NuLu Review Overlay District

Report to the Committee

Case No: 23-OVERLAY-0012
Classification: Non-Expedited
Meeting Date: September 20, 2023

Property Address: 615 & 625 E. Market Street

E. Market (South) Façade with and without the Joe Ley building

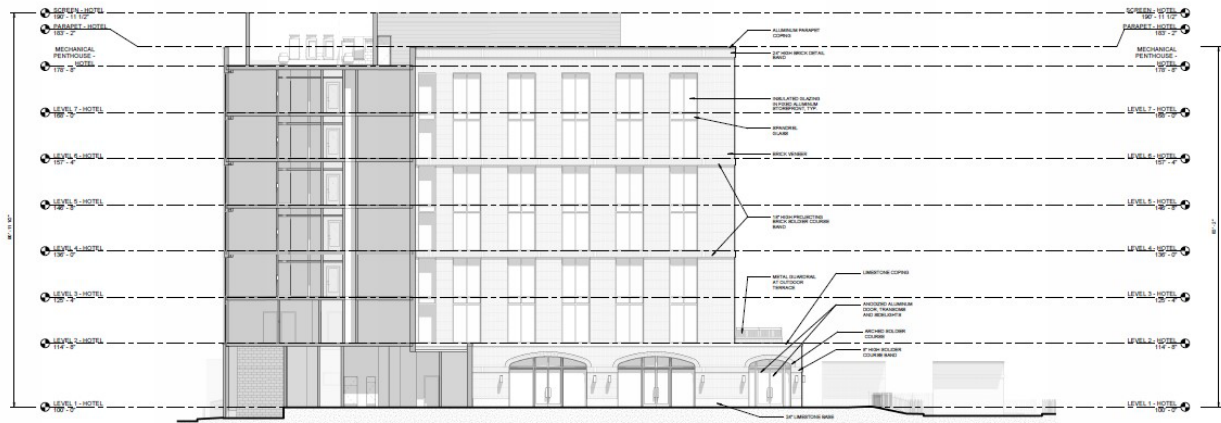
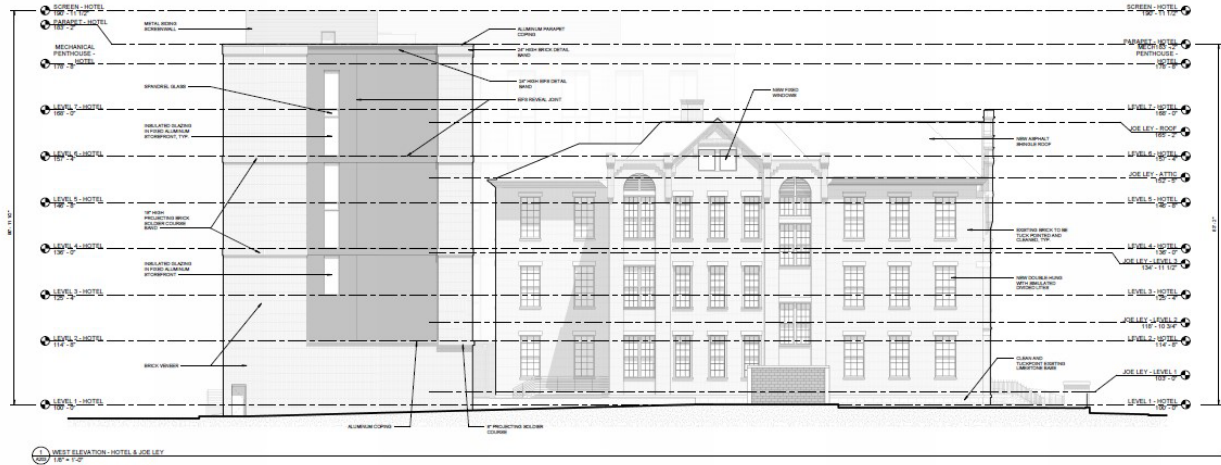
Based on the renderings and elevations provided as of the drafting of this report, staff prefers the mostly glass hyphen structure between the existing Joe Ley building and the new addition as shown in previously submitted renderings. The use of glass is less visually intrusive to the historic Joe Ley building and provides a more seamless connection between the historic and new portions of the site. Staff recommends this hyphen retain the glass design as previously proposed.

- 3. The previously proposed, mostly glass hyphen between the existing Joe Ley building and the new addition will be reincorporated into the final design.**
